DATE May 20, 2026
FOR Telluride Public Works Transit Building Addition
Telluride, Colorado
EIDOS PROJECT NO. 23019

CONTRACTOR QUESTIONS

END OF ADDENDUM NO. 5

PROPOSED NORTH ELEVATION

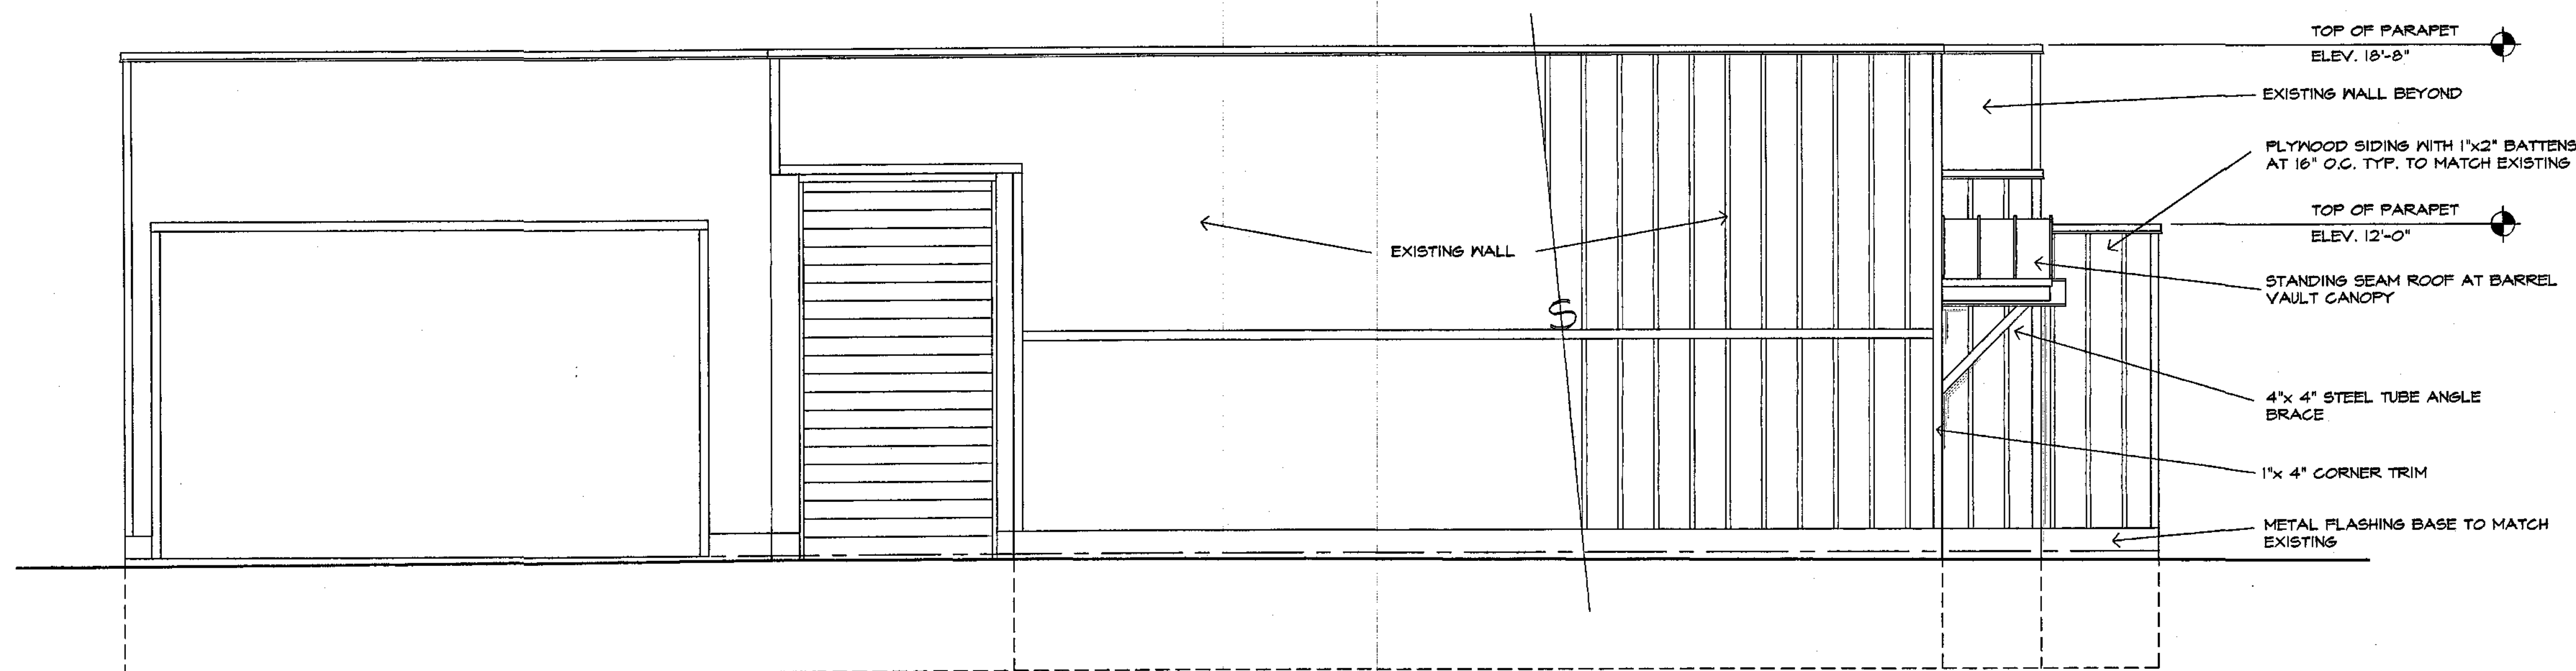
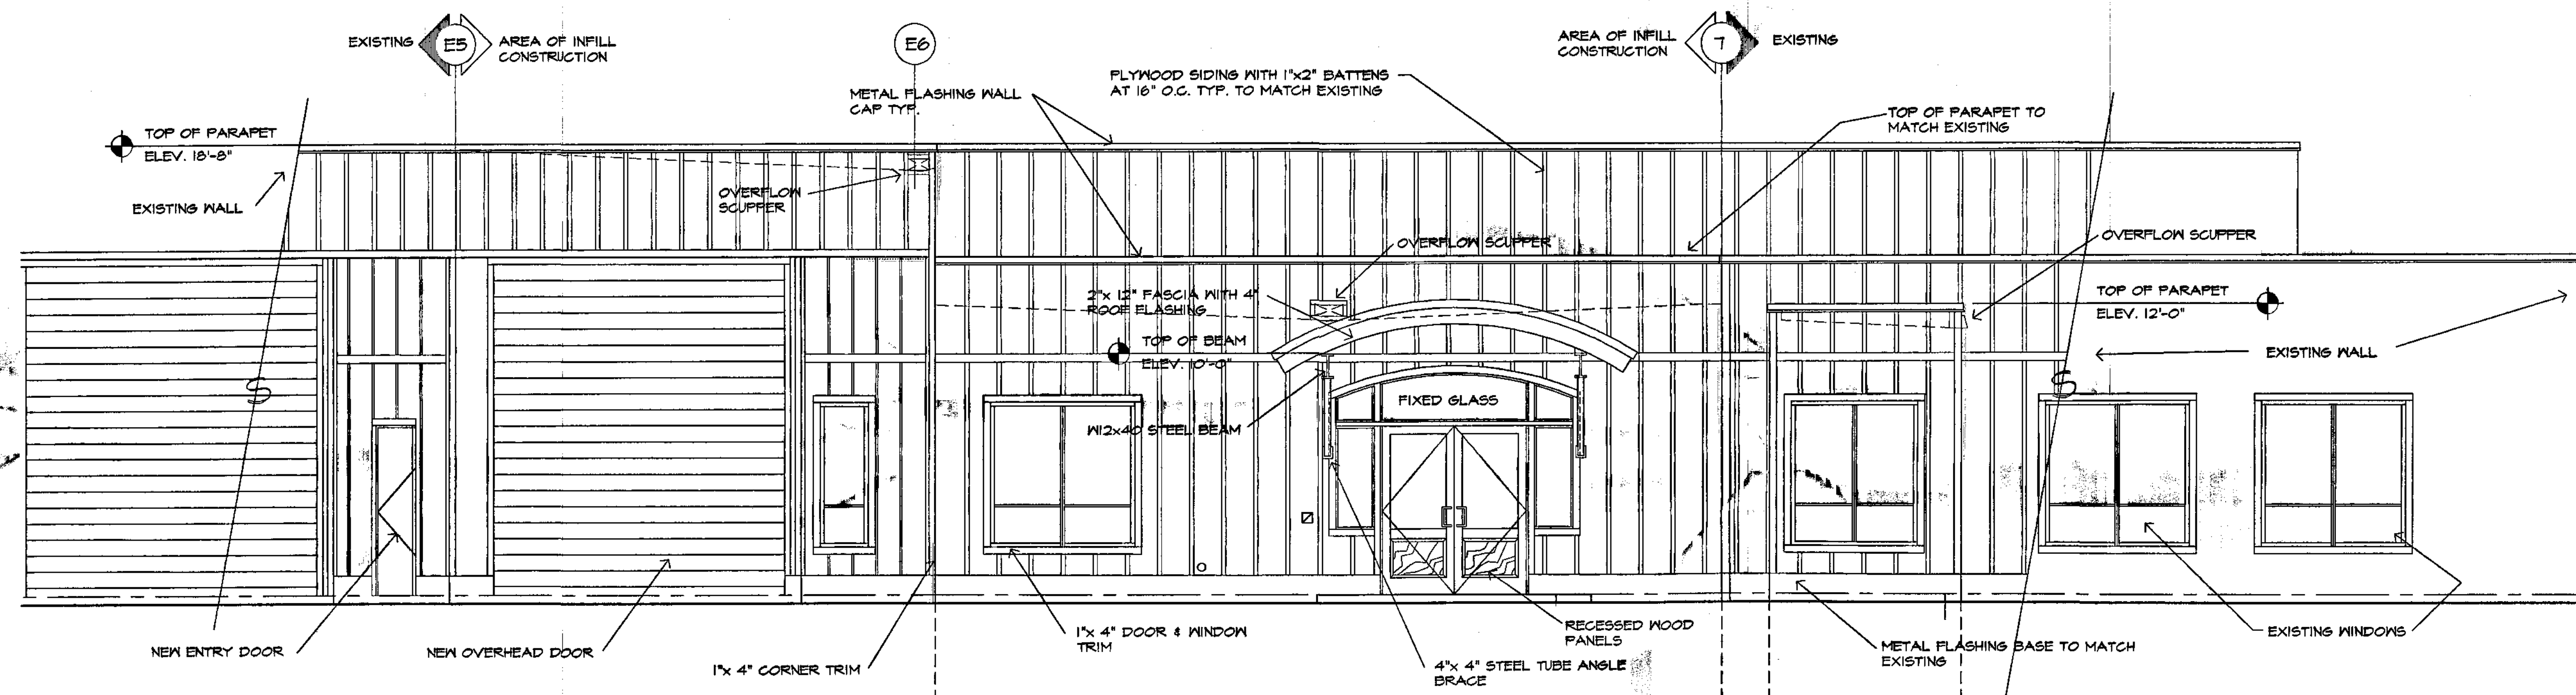
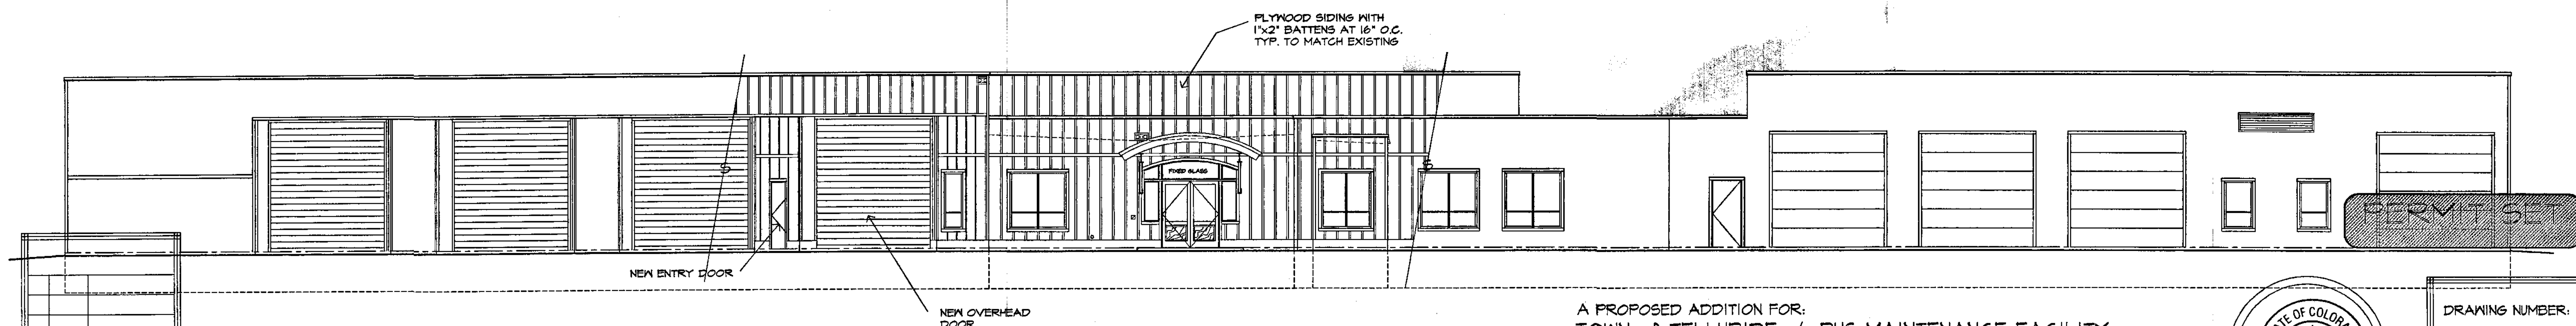
35. Alternate No. 1 includes repair and repainting of existing exterior siding and trim, and prep/repainting of existing hollow metal doors, garage doors, parapet trim, louvers, downspouts, and previously painted conduits. The drawings do not appear to clearly identify the limits, locations, or quantities of this work. For bidding purposes, please provide quantities and locations for each of the following items to ensure apples-to-apples pricing:

- Existing exterior siding to be repaired and repainted
- Existing exterior trim to be repaired and repainted
- Existing hollow metal doors to be prepped and repainted
- Existing garage doors to be prepped and repainted
- Existing parapet trim to be prepped and repainted
- Existing louvers to be prepped and repainted
- Existing downspouts to be prepped and repainted
- Previously painted conduits to be prepped and repainted
- If quantities are not available, please provide a defined allowance or unit-price basis for this scope.

Answer: The intent is to include repair and repainting of the existing exterior siding, trim, doors, garage doors, parapet trim, louvers, downspouts, conduits, and windows as needed to match the new addition. Attached are the existing building elevations that are currently available, but do not show all walls.

REFLECTED CEILING PLAN

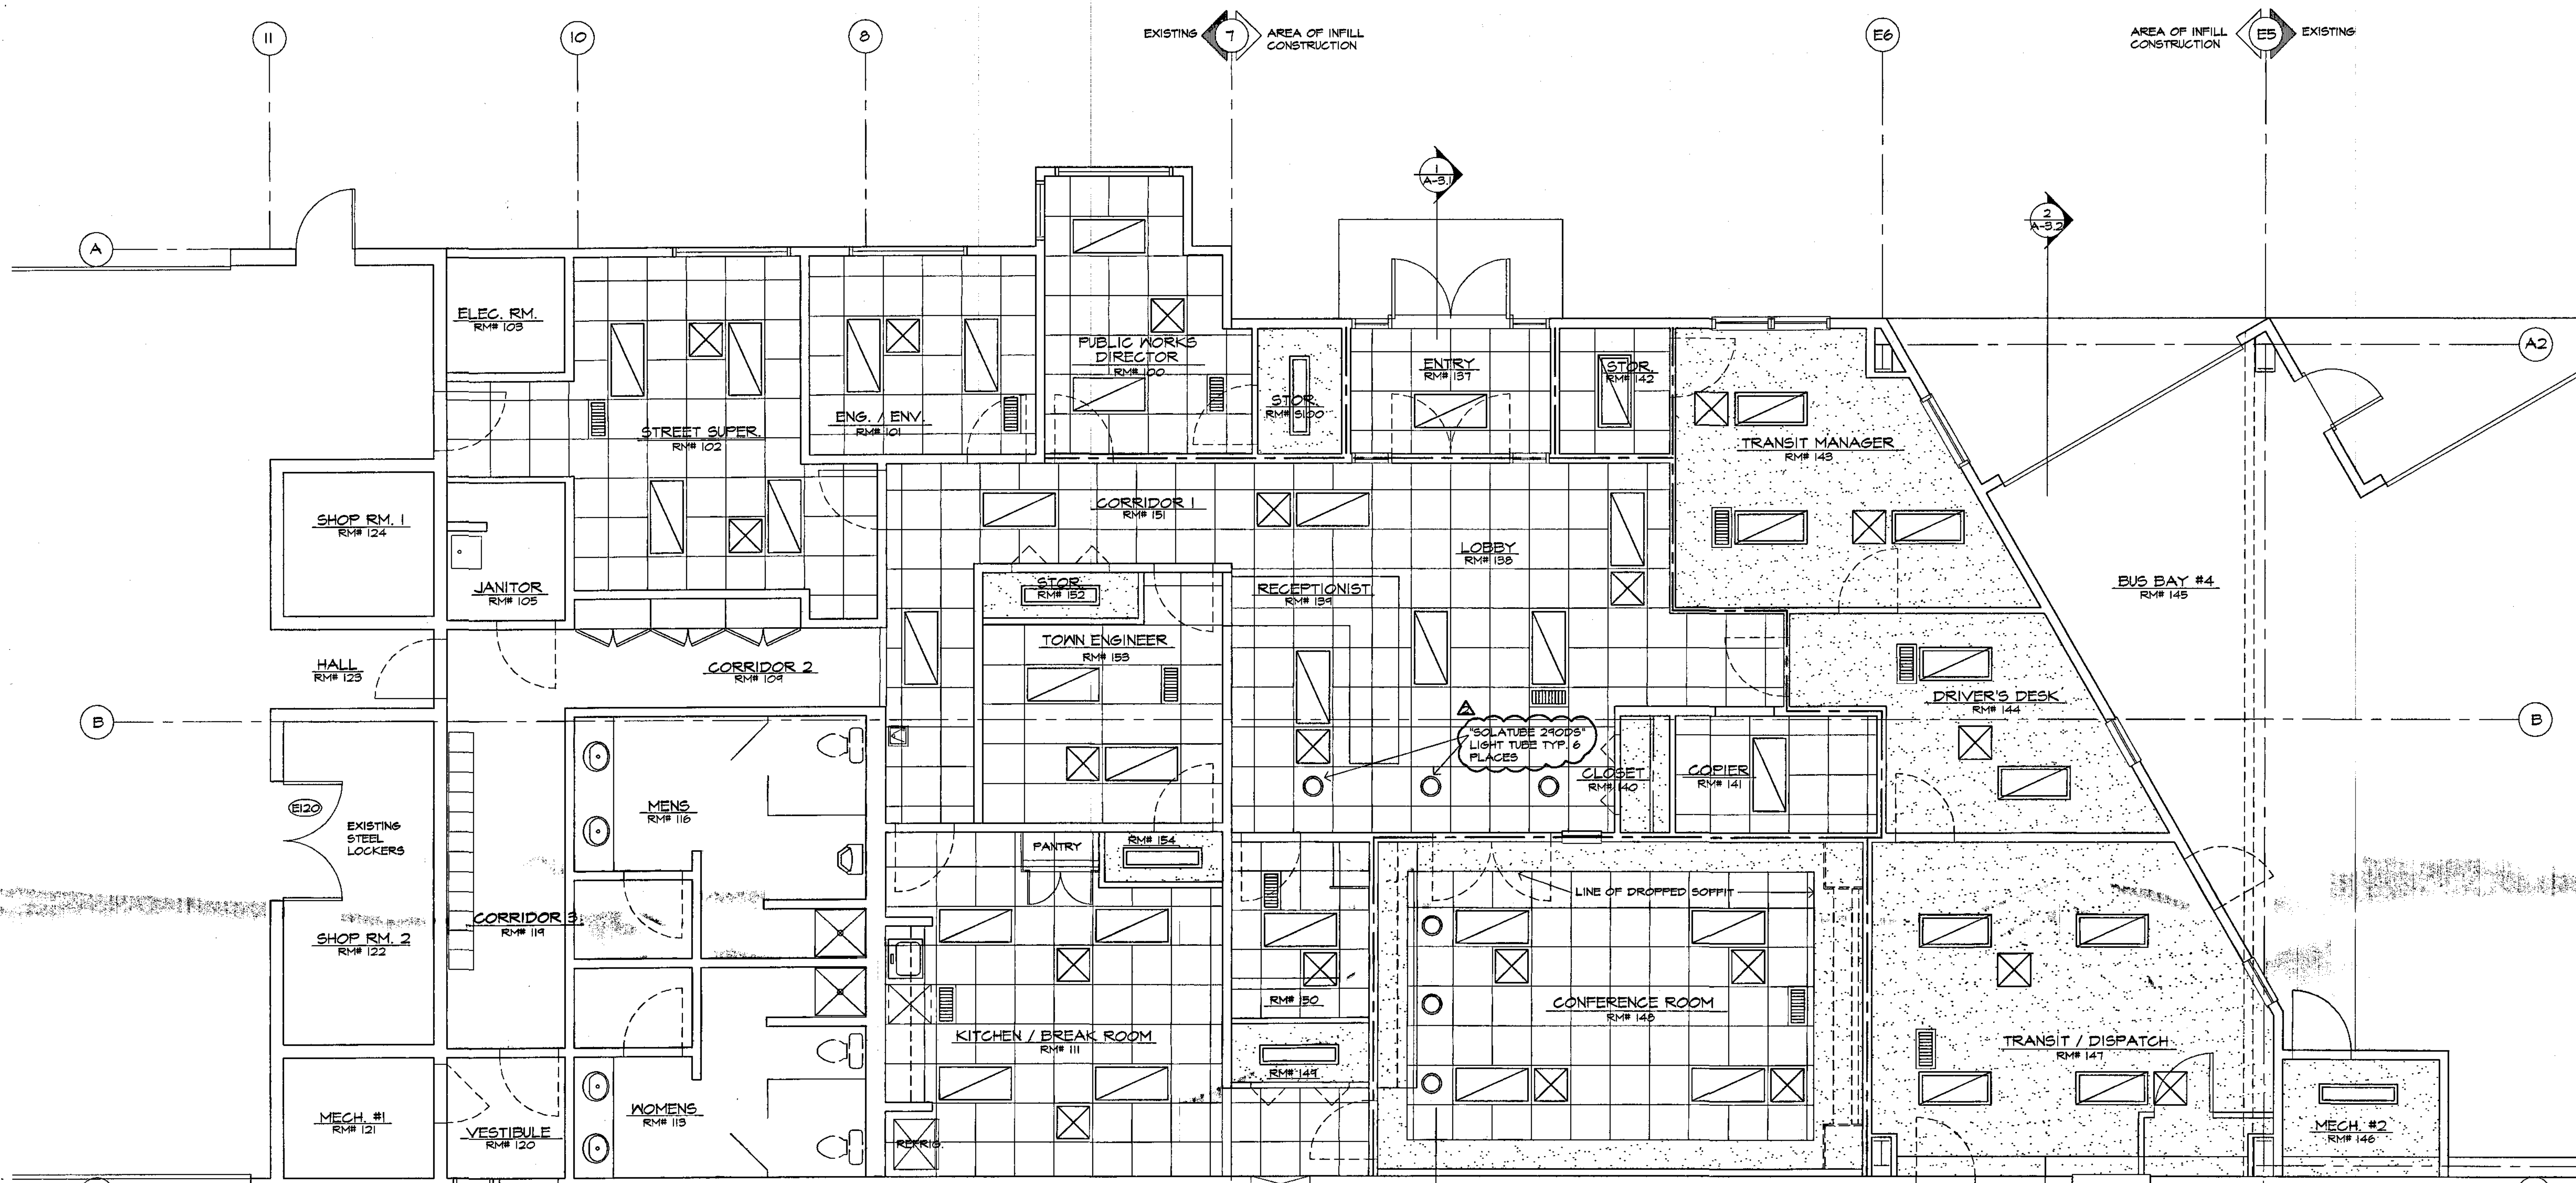
8. The project scope and code review indicate that fire suppression and fire alarm systems are to be provided throughout the combined existing and new building. Can an overall existing building reflected ceiling plan, or a ceiling plan identifying the existing ceiling conditions, be provided to show where and what types of ceilings may need to be removed, modified, patched, or replaced to accommodate the new fire suppression piping in the existing building?

Answer: Attached are the available ceiling plans from the existing administration area. The vehicle bays do not have finished ceilings. Drawings are not verified with actual conditions, but shall be used for bidding purposes.
